AURIX™ TC22x/TC21x errata sheet

Marking/Step: ES-AC, AC

About this document

Figure 1 Example sequence showing how registers ETRRx may be filled with "Error Free" addresses

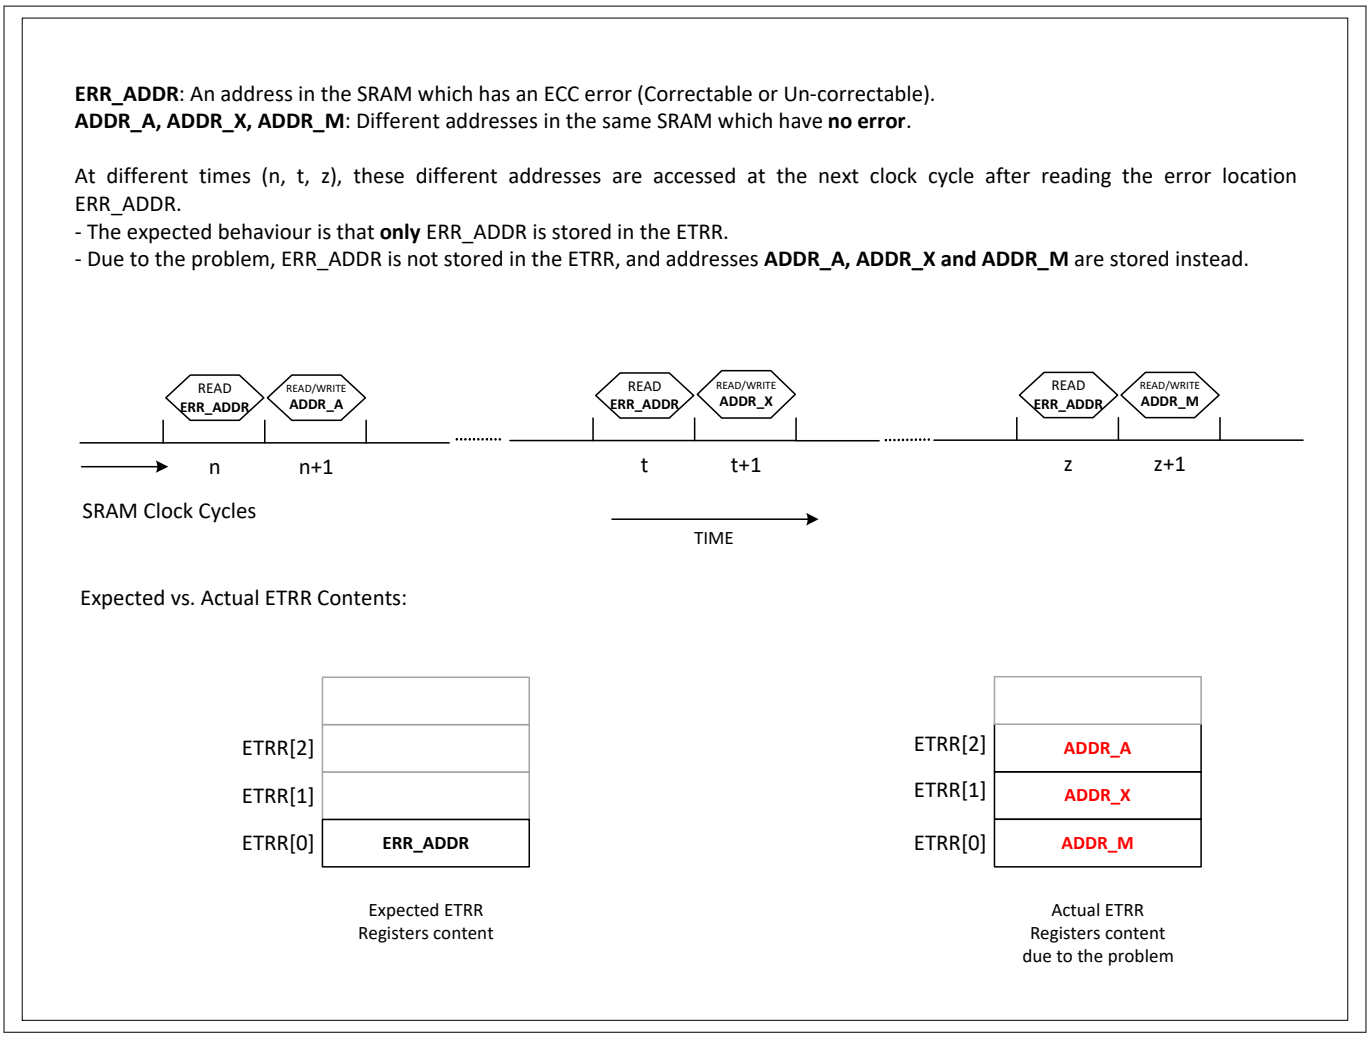
When such a consecutive access sequence (read from ERR_ADDR followed by read/write of different address(es)) happens multiple times, registers ETRRx are filled with addresses that have actually no error – and the SRAM address which actually has an error is not stored indeed. Figure 1 shows such an example scenario.

The consequence of the scenario explained in Figure 1 is that a single error in the SRAM – example just one correctable error at a location ERR_ADDR – can result in registers ETRRx getting filled with fault-free address, and thus potentially even triggering an ETRR overflow.

1. For the affected SRAMs, the addresses stored in ETRRx may not be reliable. Depending on the access sequences, ETRRx may contain the correct error address, or in the worst case all ETRRx entries may contain fault-free addresses
2. Depending on the access sequences, an ETRR overflow might be triggered with one real error (for example correctable error) in the SRAM – consequence of the example shown in Figure 1

Figure 2 Recommended Software Handling - Flowchart

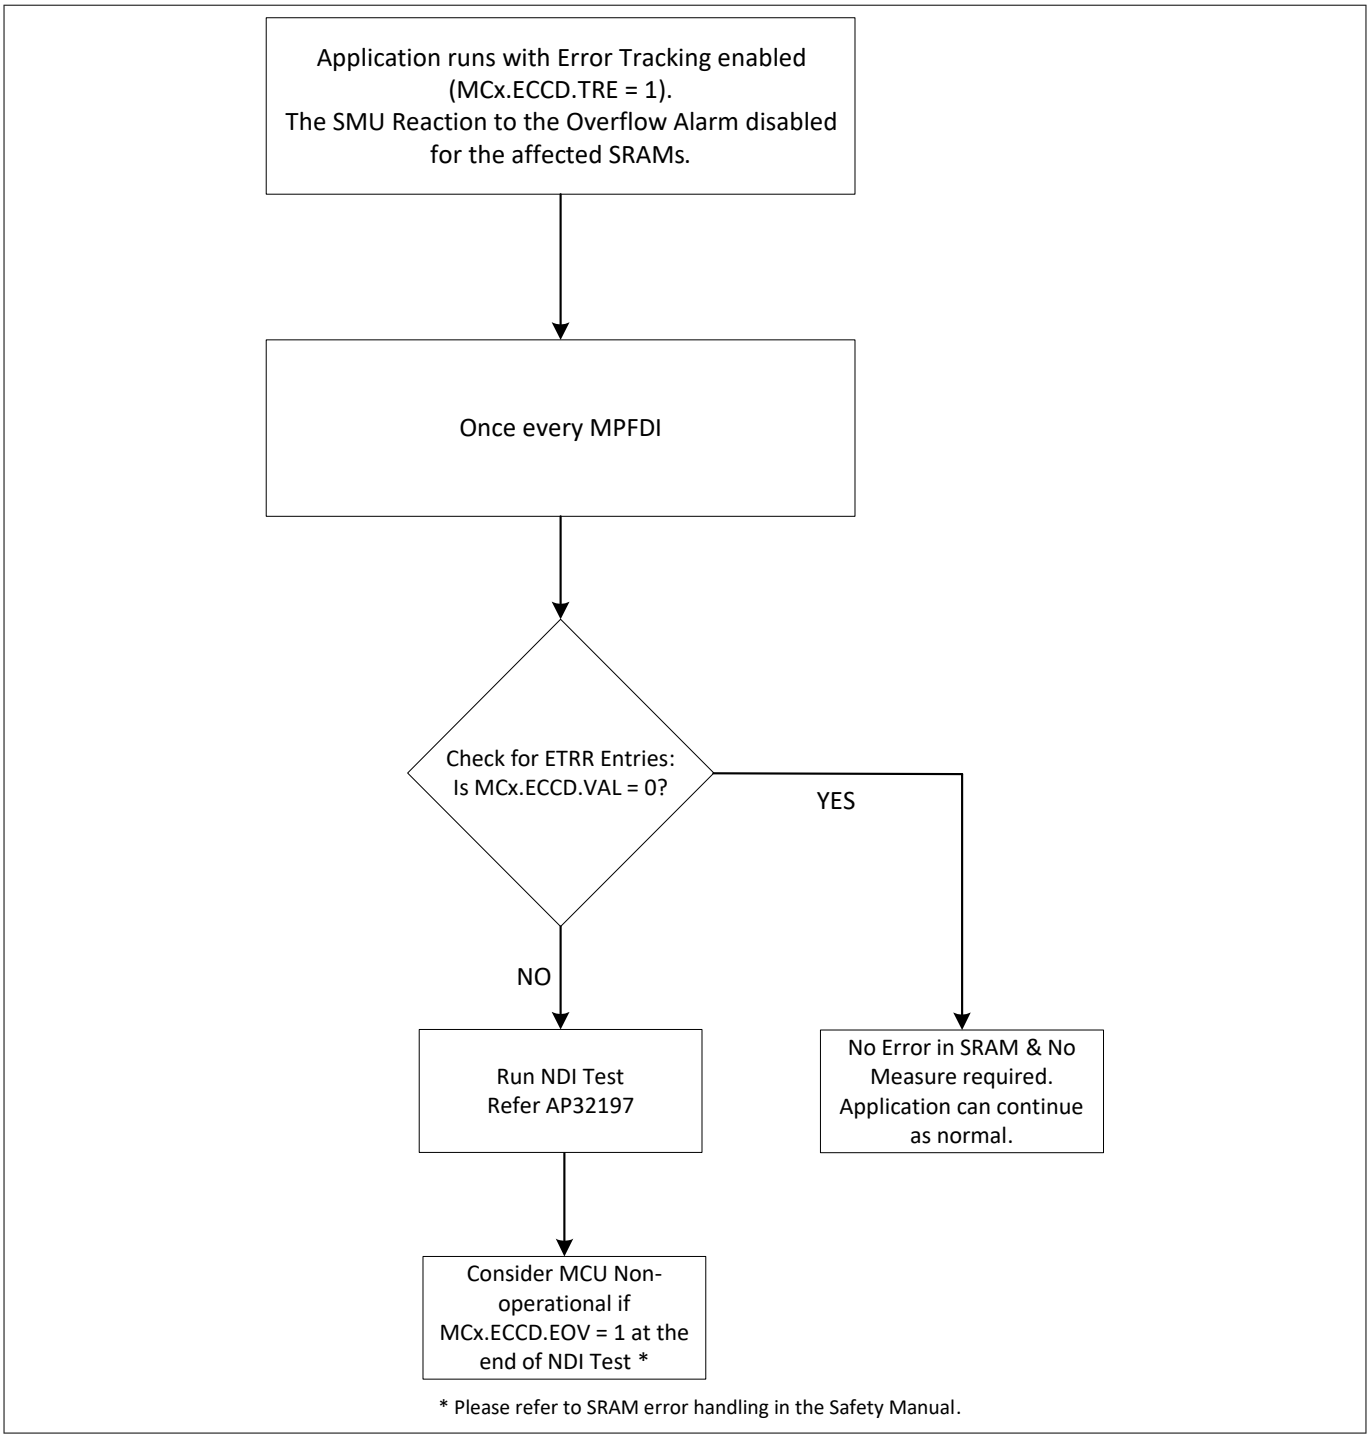
A flowchart of the recommended software handling is shown in Figure 2.

If there is at least one valid ETRR entry (i.e. MCx.ECCD.VAL ≠ 0) then the software shall run a Non-Destructive-Inversion (NDI) Test on the affected SRAM. Please refer to application note AP32197 (AURIX™ Memory tests using the MTU) for an example regarding running this test.

At the end of this test, if an ETRR overflow is detected (MCx.ECCD.EOV = 1_B) then the MCU shall be considered non-operational. Refer to section on Correctable SRAM Error handling in the Safety Manual.

Figure 8 Package Outlines TQFP-144 for TC22x/TC21x

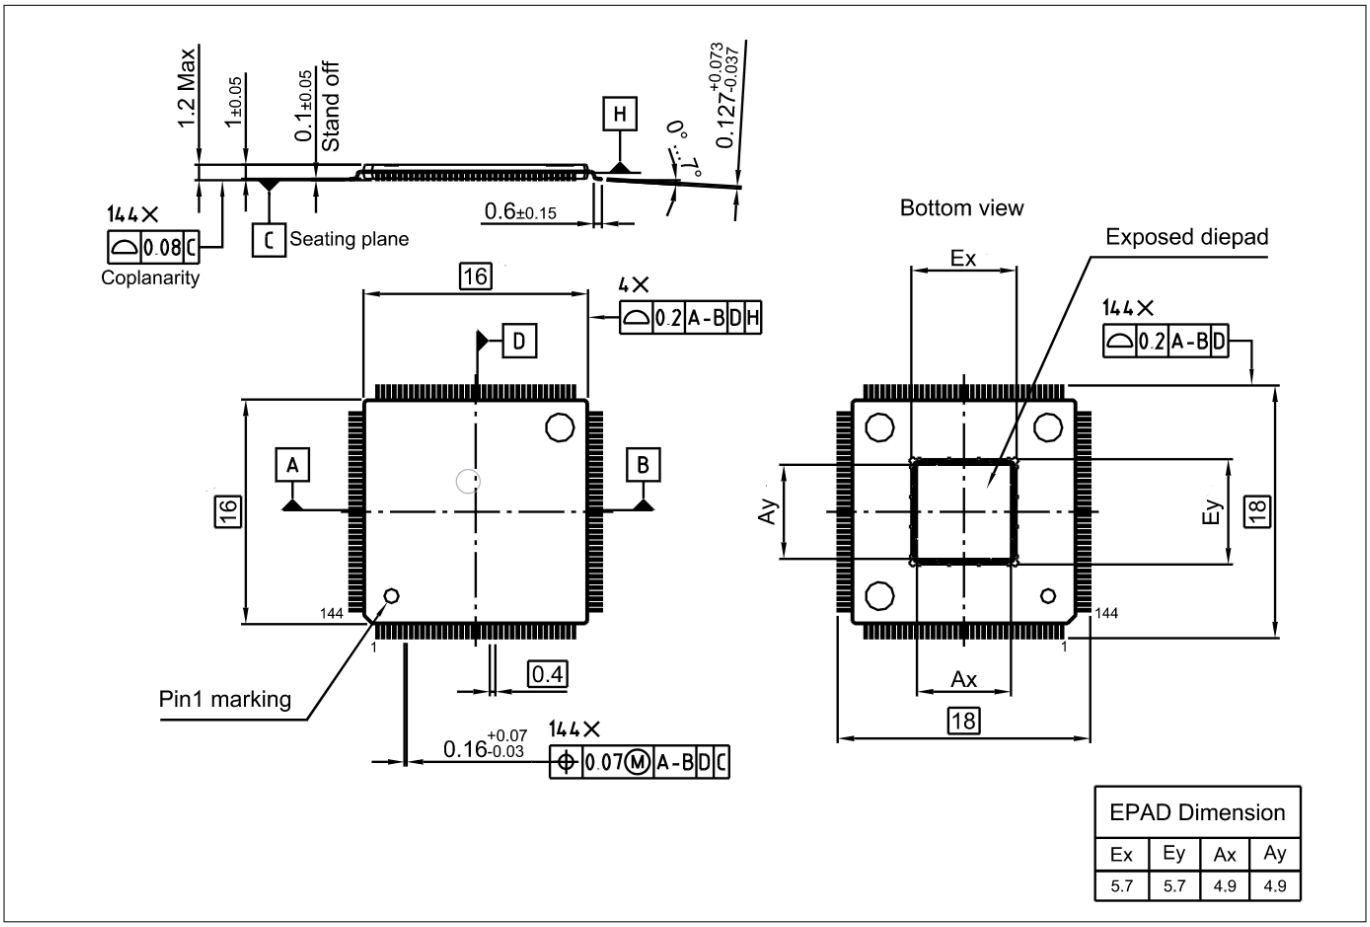
This information shall substitute the corresponding information in the TC22x/TC21x AC-step Data Sheet V1.0 and in the TC22x/TC21x A-step Data Sheet V1.0.

***Note**: For the exposed pad of the TQFP-144 package of the TC22x/TC21x, structural corner protrusions have to be considered for purposes of system design and integration with a maximum boundary of 6.2 mm.*

Figure 9 Package Outlines TQFP-100 for TC22x/TC21x

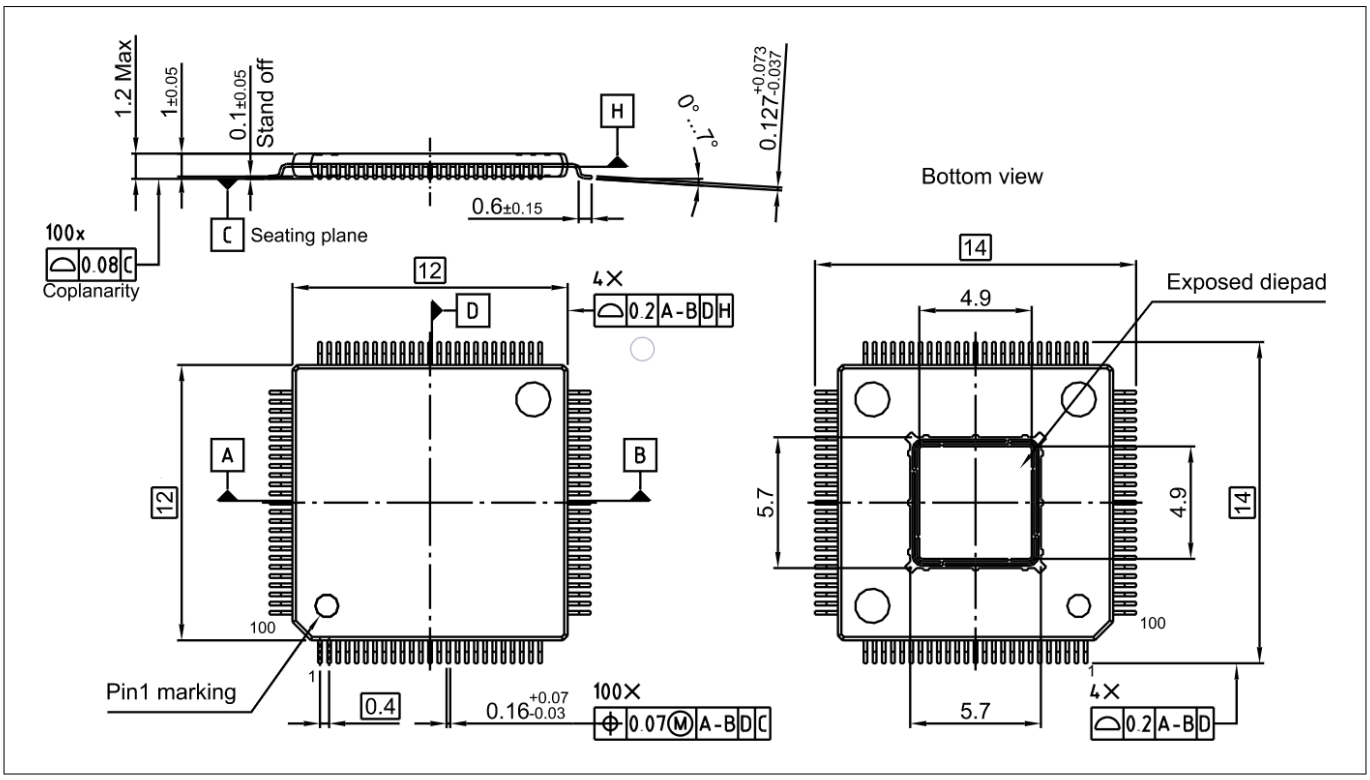
***Note**: For the exposed pad of the TQFP-100 package of the TC22x/TC21x, structural corner protrusions have to be considered for purposes of system design and integration with a maximum boundary of 6.3 mm.*

Figure 10 Package Outlines TQFP-80 for TC22x/TC21x

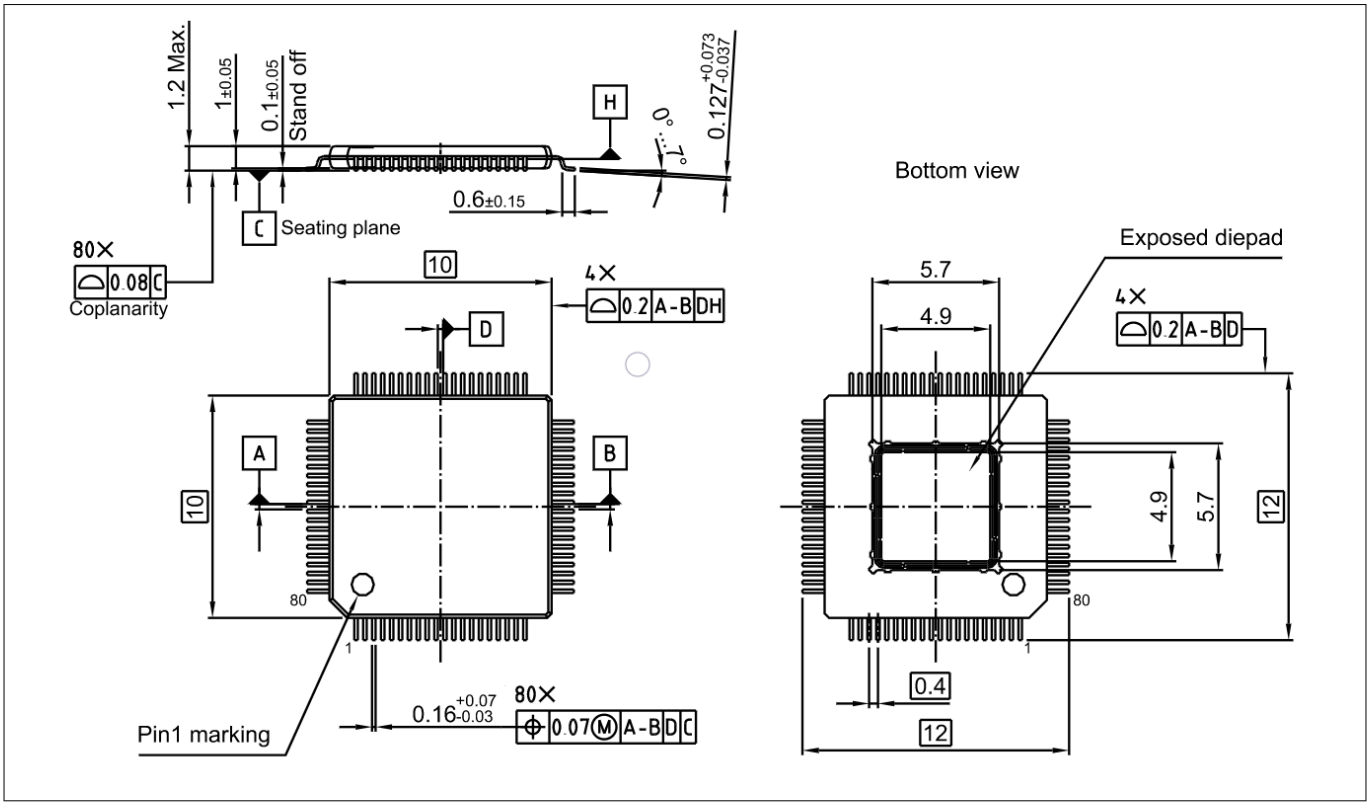
***Note**: For the exposed pad of the TQFP-80 package of the TC22x/TC21x, structural corner protrusions have to be considered for purposes of system design and integration with a maximum boundary of 6.2 mm.*

Figure 12 Short Serial Message, Serial Data Encoding over 16 messages

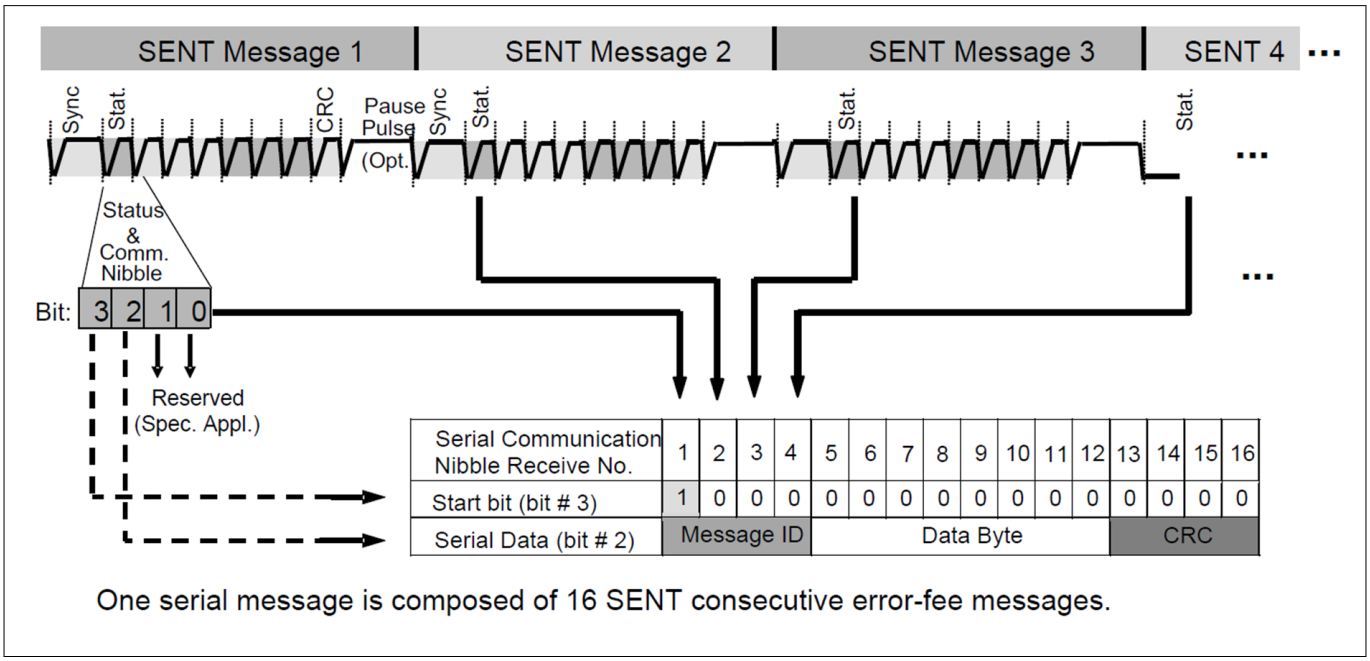
Correction

Figure 12 shows a corrected version of this figure.
